PLANNING APPLICATION Proposal

Additional Information Required for Planning Application PLN21-0325 Multiple dwellings x 5 at 15 Monastery Court, Longford

Additional Information Required for Planning Application PLN-21-0330 - <u>Alterations and additions</u> to dwelling and 3 units for visitor accommodation at 17 William Street, Longford

EXISTING ELEVATION

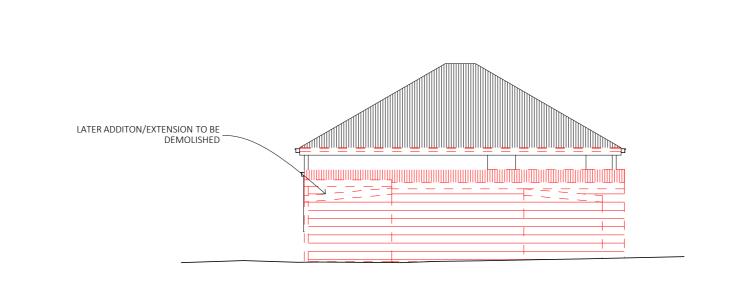
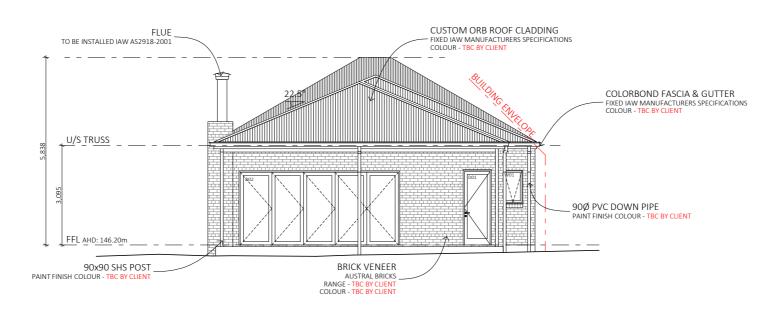
The cover letter with the DA states a portion of the existing dwelling to be demolished has a setback of 100mm, referring to a drawing showing the eastern wall of the first section of a later addition being further east than the eastern wall of the original four room dwelling.

Viewing the side of the dwelling from near the driveway of 15 William St, it appears the eastern wall of the first part of the later addition is on the same plane as the eastern wall of the original dwelling (see below).

DRAWING **DWELLING** ELEVATIONS STH SIGNATURE:

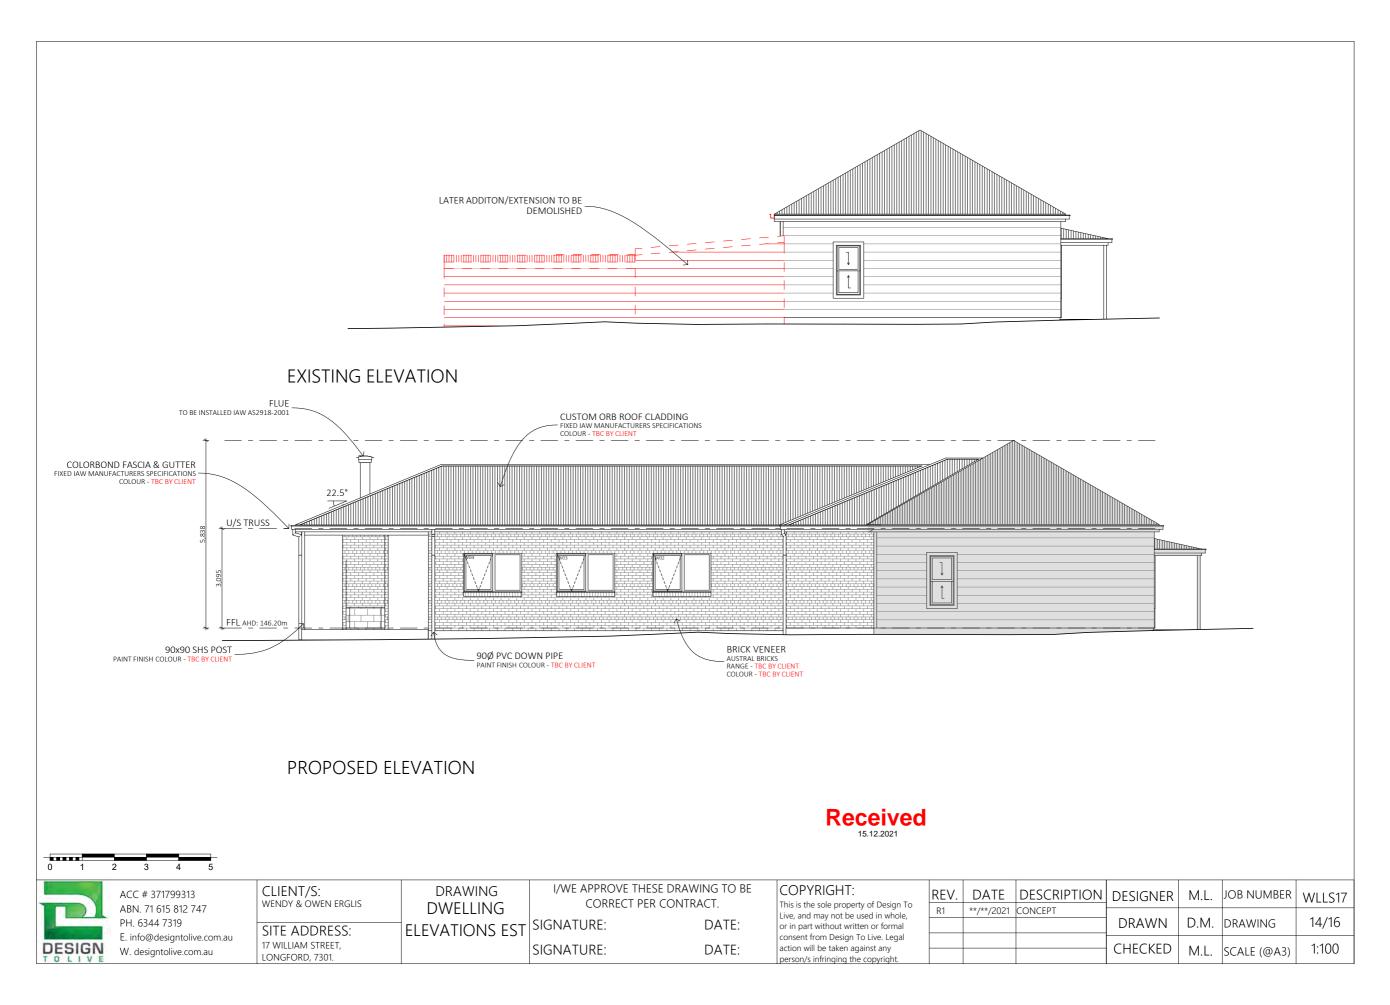
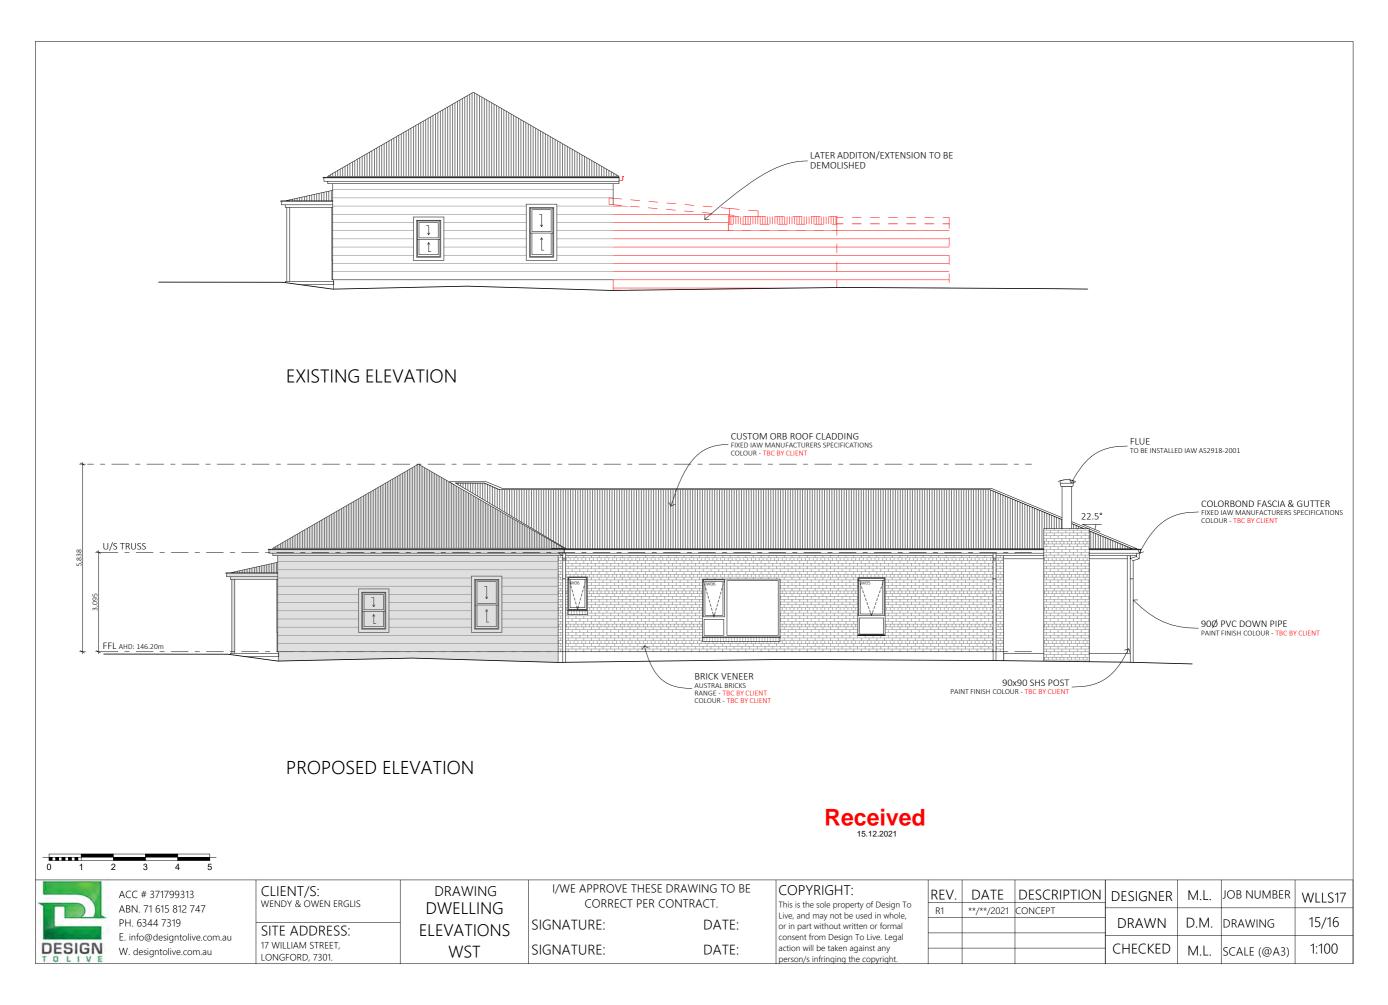
Refer to WLLS17/13 (Dwelling Elevation Sth). All but the gutter of the proposed extension is contained within the building envelope as outlined in 10.4.2 A3. The protrusion of the gutter will not cause any loss of amenity to adjoining properties in regard to sunlight and private open space as the immediate area at the eastern boundary is driveway access to the existing dwelling located at 15a William Street.
